intel® Technical Advisory

TA-240-1

January 14, 2000

Some L440GX+ based servers may experience a system hang when add-in cards are installed in PCI slots 5 or 6

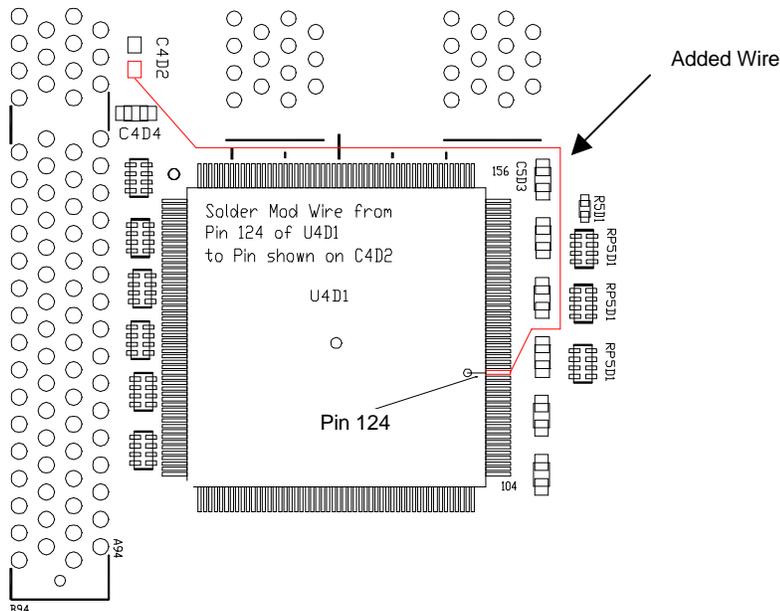
Intel's Server Products Division (SPD) test labs have reproduced a system hang on some L440GX+ based servers by installing PCI cards requiring a high I/O bandwidth, such as a SCSI RAID controller, into PCI slots 5 or 6. The hang has been seen to occur after POST while either booting an Operating System or while performing data transactions on the secondary PCI bus using a system stress program.

A manufacturing process variation may have affected operation of the 21150BC Bridge chip's internal clamp circuits when exposed to fast edge rates. This process variation may have contributed to a marginal condition between the 440GX chipset and the 21150BC Bridge chip on some L440GX+ server boards.

The Intel SPD Engineering team has developed a software fix for this issue and has incorporated it into a new System BIOS, version 11.1. Compensation circuits on the 440GX will be enabled through a buffer strength setting in the BIOS to reduce the effect of the edge rates to the 21150BC bridge chip. System BIOS 11.1 will be installed on all L440GX+ server boards in our factory, is posted to IBL, and will be made available on Intel's Support web site at <http://support.intel.com>.

In addition, hardware changes will be made to the server board design to further decrease the possibility of failures. Intel manufacturing will be implementing a change, for all new shipments, by routing a 5volt signal to pin 124 of the 21150BC bridge chip.
